Subject: Grand Gulf Nuclear Station
Docket No. 50-416
License No. NPF-29
Technical Specification Bases Update to the NRC for Period April 27,
2001, through May 2, 2001

GNRO-2001/00037

**GGNS Gulf Technical Specification Bases Revised Pages
for
Period April 27, 2001
Through
May 2, 2001**

BASES FIGURE B 3.3.1.1-1 REACTOR VESSEL WATER LEVEL

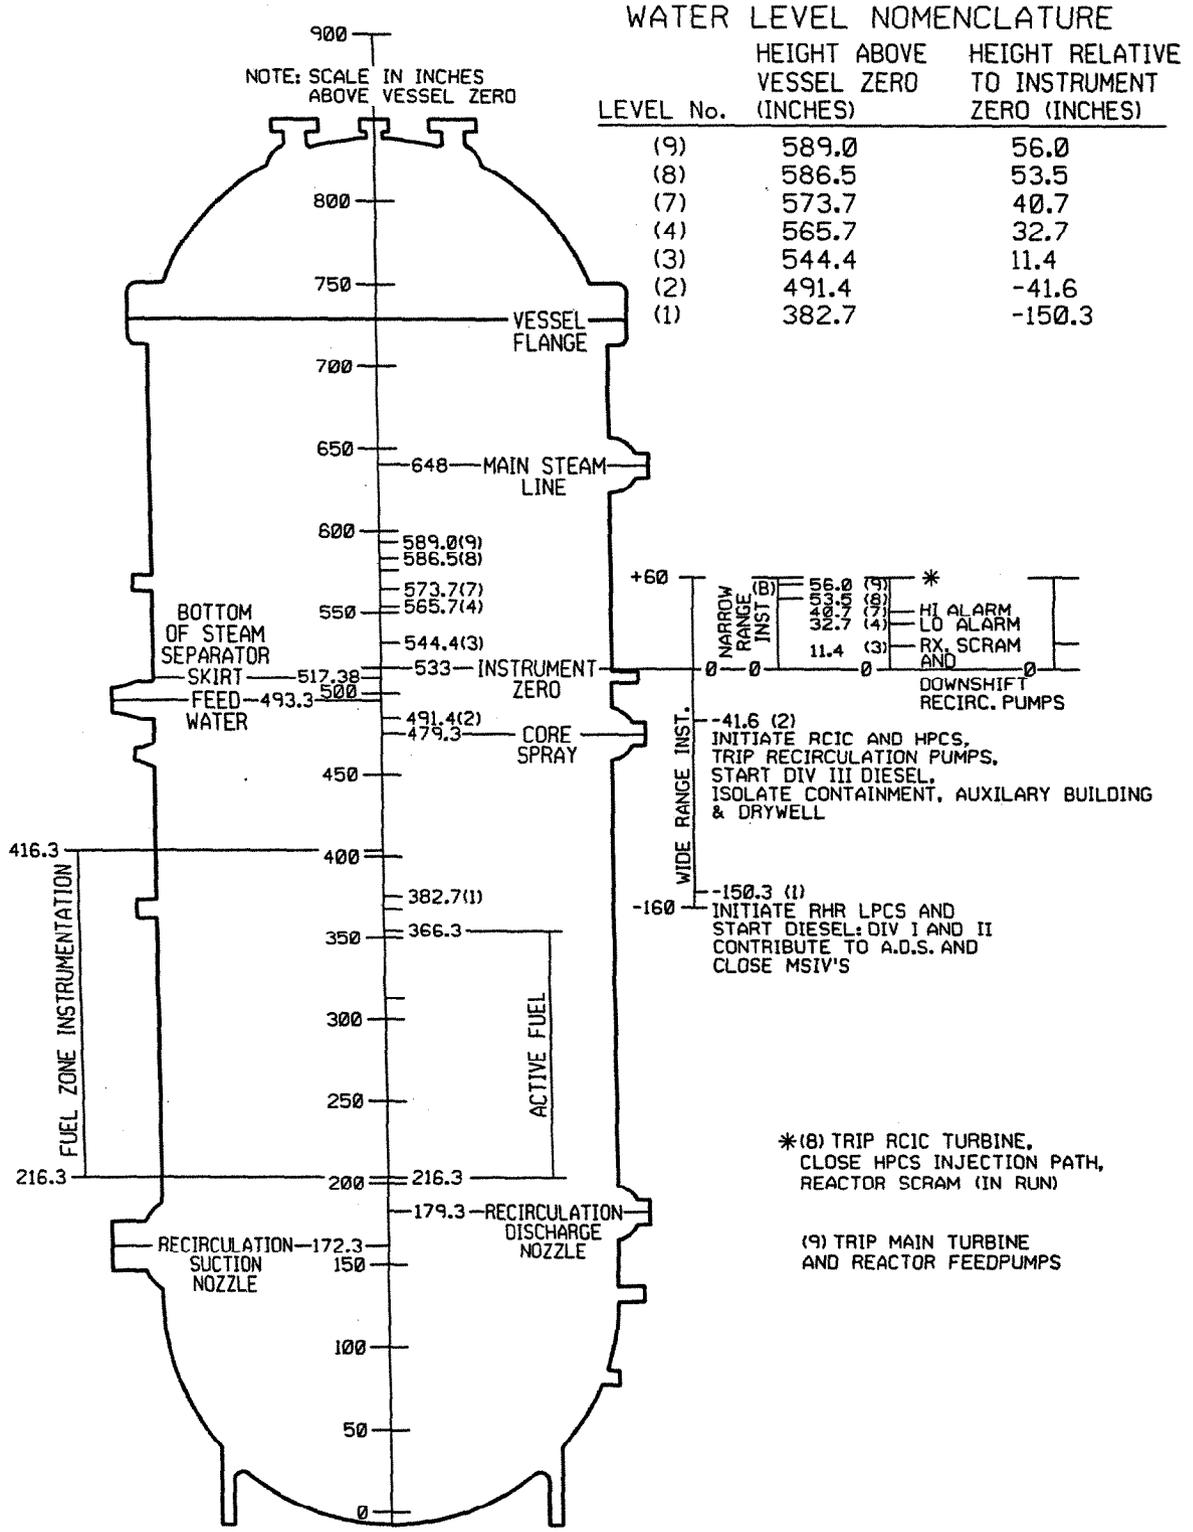
LDC#	BASES PAGES AFFECTED	TOPIC of CHANGE
00076	B 2.0-2, B 2.0-3, B 2.0-6,B 3.2-5, B 3.2-6, B 3.2-8	Fuel Reload for Cycle 12 Operation; Implementing Amendment No. 146 (GNRI-2001/00056)
01071	B 3.3-30a	Correct editorial errors in TRM Table 6.3.1-1 and Tech Spec Bases Figure B 3.3.1.1-1
